TO: Mercedes-Benz Dealer Principals, General Managers, Sales Managers, Service Managers, Parts Managers	FROM: Gregory Gunther, Department Manager, Vehicle Compliance and Analysis, Engineering Services
RE: Recall Campaign Launch Notification Replace Steering Control Unit Wiring Harness MY20 253 (GLC-Class)	Date: December 08, 2020

Campaign No. :	NHTSA ID	Campaign Desc. :	Replace Steering Control Unit Wiring Harness
2020110012	20V651	20P5491022

SUBJECT: **Model GLC-Class (253 platform)**
Model Year 2020
Replace Steering Control Unit Wiring Harness Insulation

Figure 1 (Routing in cable duct)

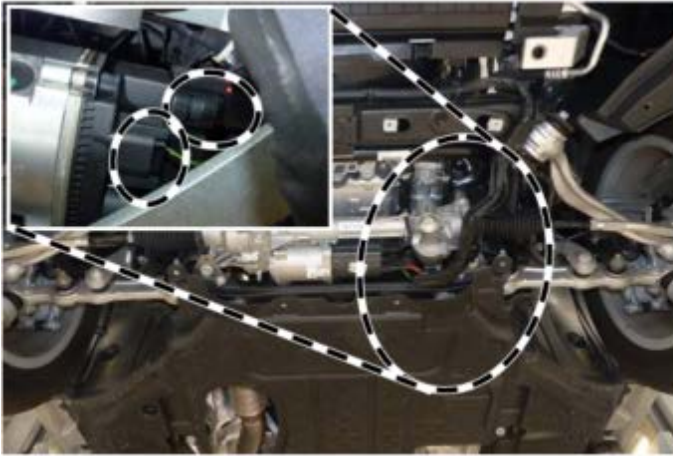
1. Switch off ignition and store vehicle key at least 2 meters away from vehicle.
2. Remove lower engine compartment lining.
For basic data for model 253, see **AR61.20-P-1105LW**;
3. Release and remove both connectors at steering control unit (**figure 1**).
4. Check connector of **red** power supply cable and **brown** ground cable for moisture.
i In the case of moisture, make detailed photos, create the steering (N68) control unit log and clarify the further repair procedure via **PTSS case**.
5. Expose wiring harness up to a length of 300 mm from the connector. This can be achieved by sliding back the protective hose.
i There are two different cable routings (**figure 1**).

i In the case of routing in cable duct

1. Release cable duct.
2. Mark position of cable ties so that these are located at same position during the installation.
3. Release cable ties (from the connector, the first four) and remove lines from cable duct.
4. Slide back the protective hose for check purposes.

i In the case of routing in the protective hose without cable duct

1. Mark position of cable ties so that these are located at same position during the installation.
2. Release cable ties (starting from the connector, the first two) and slide back the protective hose.
